Work Order ID 78496

Item ID: D205-634-141 Accept ***N900040100*** Setup Start ***NS1***
 Revision ID: Stop ***NS2***
 Item Name: Replacement Skidtube
 Start Date: 10/01/2012 Start Qty: 1.00 ***1*** Cust Item ID:
 Required Date: 16/01/2012 Req'd Qty: 1.00 ***1*** Customer:
 Reference:

DRAWING NO. D2580	TITLE 205 SKIDTUBE ASSEMBLY	REV. E	DART AEROSPACE LTD ENGINEERING ORDER	D.E.O. NO. D2580-E-1	SHEET NO. SHEET 1 OF 1	SCALE NTS
DRAWN <i>UP</i>	CHECKED <i>ASS</i>	MFG. APPR. <i>ER</i>	APPROVED <i>[Signature]</i>	DE APPR. <i>[Signature]</i>		
DATE 11.12.13	DATE 11.12.13	DATE 11.12.13	DATE 11.12.13	DATE 11.12.13	DATE 11.12.13

CHANGE ALL C'BORED WELDED CROSSBOLT SPACERS TO SWAGED SPACERS

SECTION B-B, F-F, I-I
NOT TO SCALE

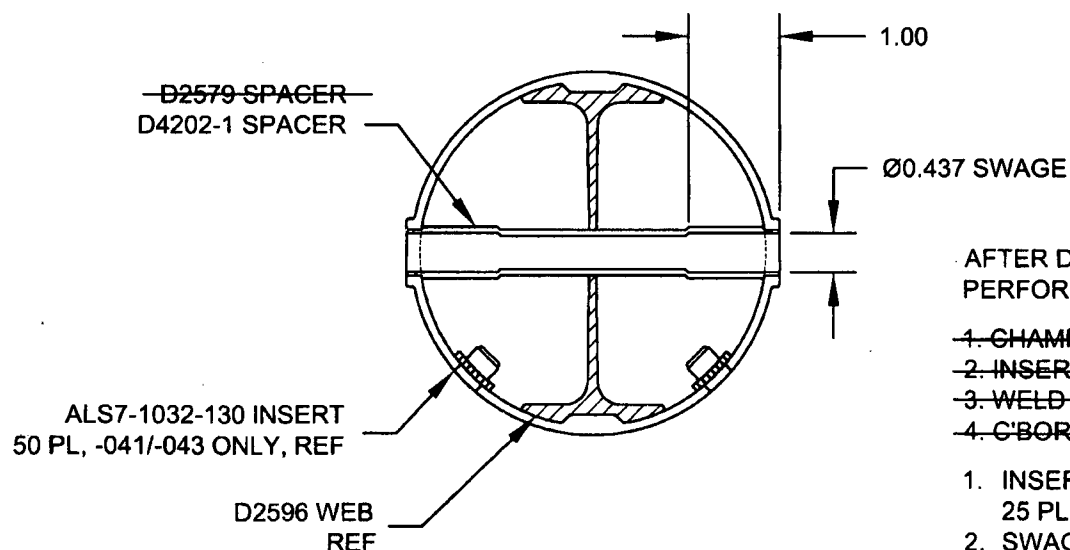
PARTS LIST IS AMENDED AS FOLLOWS:

WAS

QTY	QTY	QTY	PART NUMBER	DESCRIPTION
-041	-045	-047		
20	24	25	D2579	CROSS BOLT SPACER

IS

4		* D2579	CROSS BOLT SPACER
20	20	25	D4202-1	SPACER

SECTION B-B, SECTION F-F, & SECTION I-I ARE AMENDED AS FOLLOWS
FOR ALL HOLES THAT WERE ORIGINALLY C'BORED:*** FOR -045 SKIDTUBE ONLY:**WELD 4X D2579 SPACERS PER DWG
IN LOCATIONS MARKED "NO C'BORE".
REF SHEET 4 OF DWG.RELEASED
2011-12-14 *[Signature]*AFTER DRILLING AND BENDING ASSEMBLY
PERFORM THE FOLLOWING FOR Ø0.508 HOLES ONLY:

1. INSERT D4202-1 SPACER, 20 PL (-041) OR 20 PL (-045) OR 25 PL (-047)
2. SWAGE TO Ø0.437 X 1.00 DEEP PER QSI 002
3. TRIM / GRIND FLUSH PER QSI 002
